SERVICE TECHNICAL INFORMATION

ONE POINT REPAIR

UTSUNOMIYA, November 30, 1994
 REF. NO. : SI-94-030
 CUSTOMER SERVICE H.Q.

MODEL : LCX-50/65
 SUBJECT : No display
 SYMPTOM : If the unit is operating and power is turned off for a very short period (less than 1 minute) due to a blackout, etc., the display may not appear after the power recovers. In such cases, take the following measures.

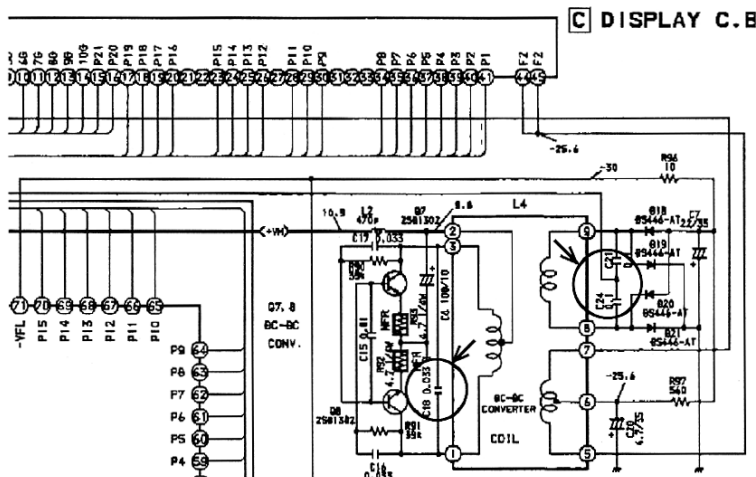
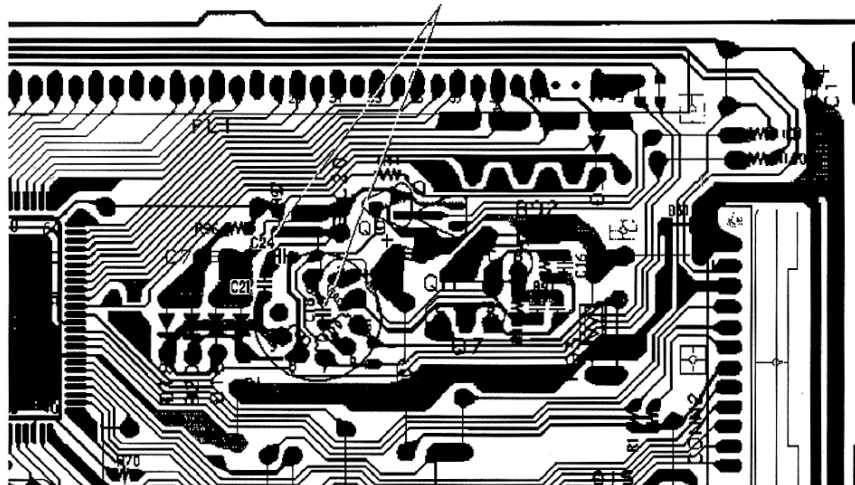
REMEDY : Change the front board chip condenser.
 Ref. No. C18 C-CAP 0.033 μ F → C-CAP 0.022 μ F BK
 C21, 24 C-CAP 0.1 μ F → CAP M 0.1 μ F

Ref.	Part Name	Part Number
C18	C-CAP, S 0.022-25B	87-010-198-089
C21, 24	CAP, M 0.1-50J	88-700-910-819
